Index 700-110 Mounting Exit Numbers Panels to Signs

LAST REVISION 11/01/23	REVISION	DESCRIPTION:	 FY 2024-25 STANDARD PLANS	MOUNTING EXIT NUMBER PANELS TO SIGNS	INDEX 700-110	SHEET 1 of 1
---------------------------	----------	--------------	--	--------------------------------------	------------------	-----------------

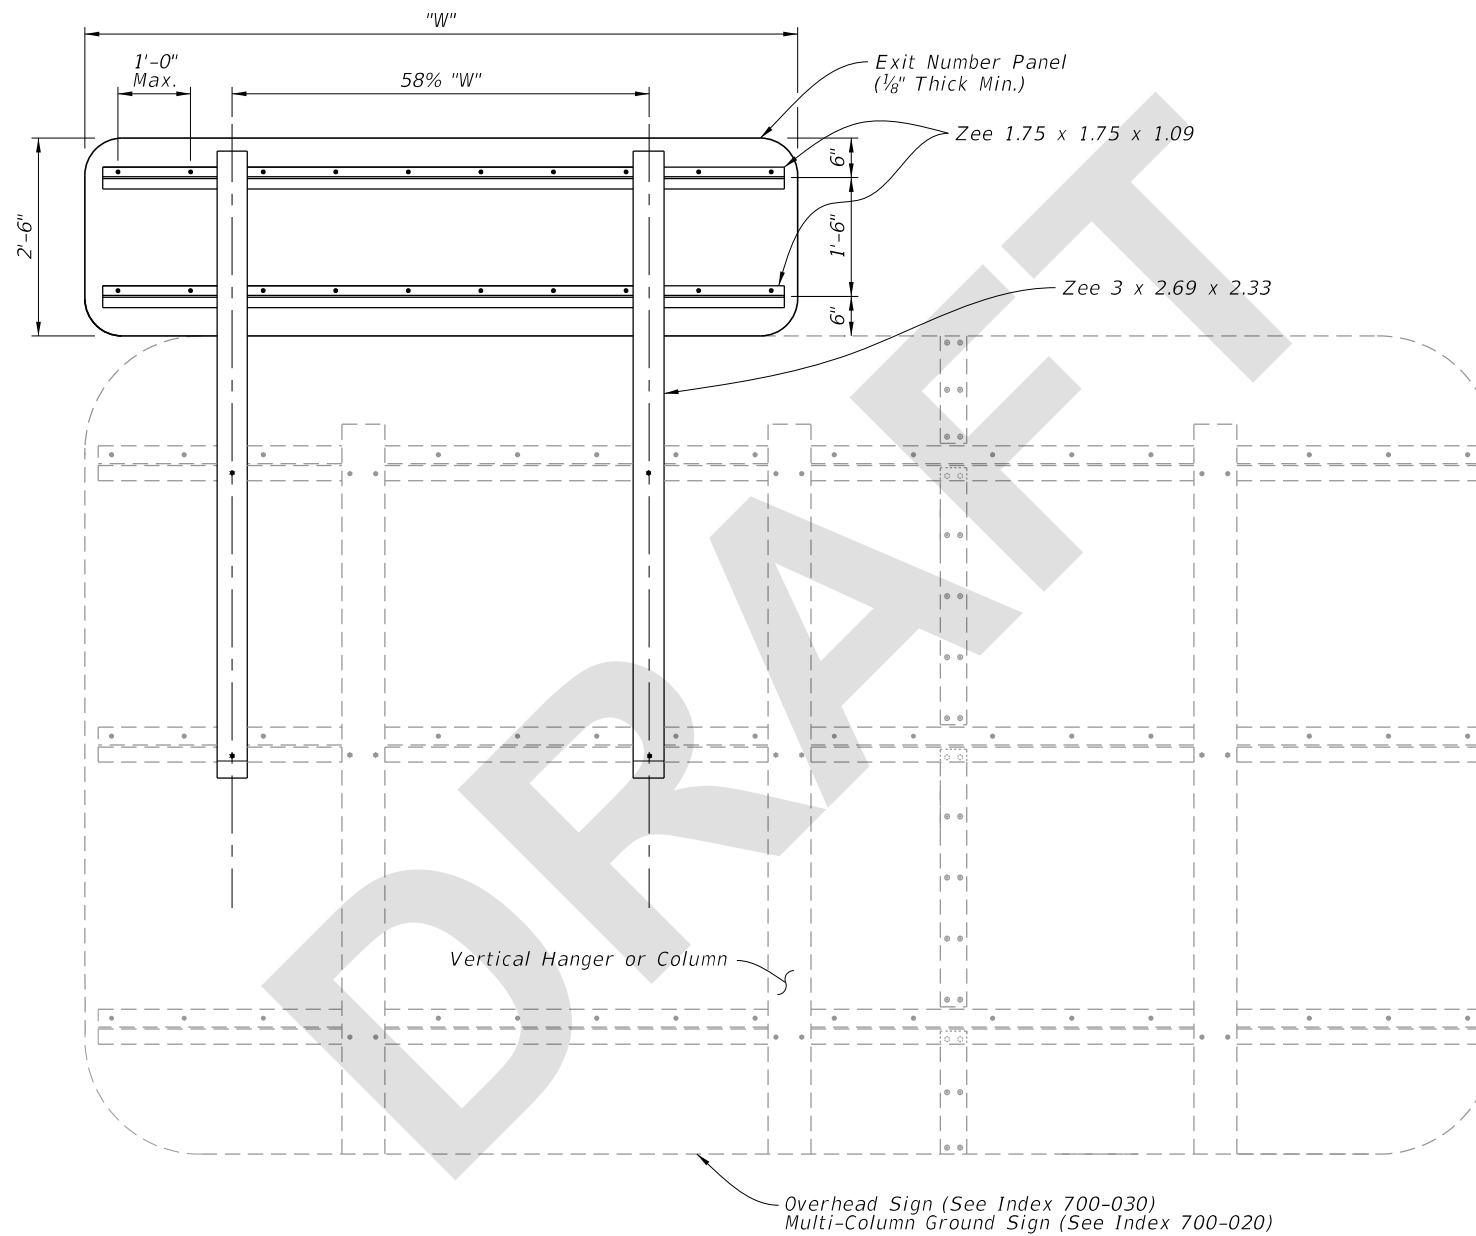
Consider matching the Exit Number Panel horizontal Zee beams to the same size as Index 700-020: “1.75 x 1.75 x 1.09”. Why use “1.75 x 1.75 x 1.08” if the difference is so minor?

RESPONSE: Thank you for this suggestion. Our Structures Office agrees so we will change it to 1.09.

CHANGE MADE TO INDEX: Yes.
